Access Compliance Report

Public Rights-of-Way

(Curb Ramps)

Intersection ID: 11096	Main Street: AVENTIDE_LN	Cross Street: CAMP_STEWART_RD	Location: SE
ADA ID: 5F7C6620C6D0	Ramp Type: Perp	Initial Pass/Fail: Fail	Overall Compliance: No
Severity Score: 33.75			
Codes/Mitigation Info/Possible Solution		Field Measurements/Component Compliance

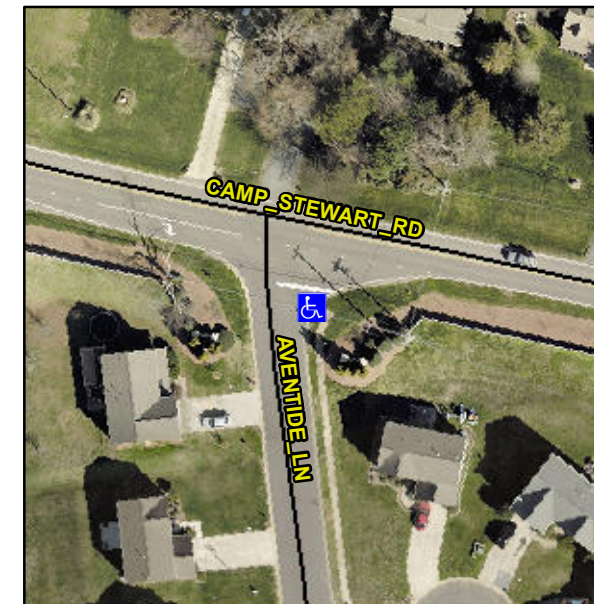
Not Found, R304.5.1, R304.2.2, R304.5.3

Compliance	Description	Data	Compliance	Description	Data
N/A	Ramp Length (in)	50.0	No	Ramp Slope (%)	9.9
No	Ramp Width (in)	43.0	No	Ramp XSlope (%)	5.2
N/A	Flare Type LT	N/A	N/A	Flare Type RT	N/A
N/A	Flare Slope LT (%)	N/A	N/A	Flare Slope RT (%)	N/A
N/A	Flare Traversable LT?	N/A	N/A	Flare Traversable RT?	N/A
N/A	Landing Length (in)	N/A	N/A	DWS Provided?	N/A
N/A	Landing Width (in)	N/A	N/A	DWS Contrast?	N/A
N/A	Landing Slope (%)	N/A	N/A	DWS Length (in)	N/A
N/A	Landing X Slope (%)	N/A	N/A	DWS Full Width?	N/A
N/A	Landing Curb? (Y/N)	N/A	N/A	DWS Offset (in)	N/A
N/A	Shared Landing?	N/A			
N/A	Gutter Ponding?	N/A	N/A	Gutter Slope (%)	N/A
N/A	Gutter Lip Ht (in)	N/A	N/A	Gutter X Slope (%)	N/A
N/A	Painted X Walk1?	No	N/A	Painted X Walk2?	N/A
	X Walk 1 Direction	To NW		X Walk 2 Direction	N/A
N/A	X Walk 1 Width (in)	N/A	N/A	X Walk 2 Width (in)	N/A
	X Walk 1 Slope (%)	2.7		X Walk 2 Slope (%)	N/A
	X Walk 1 X Slope (%)	5.6		X Walk 2 X Slope (%)	N/A

Remove & Replace Entire Ramp.
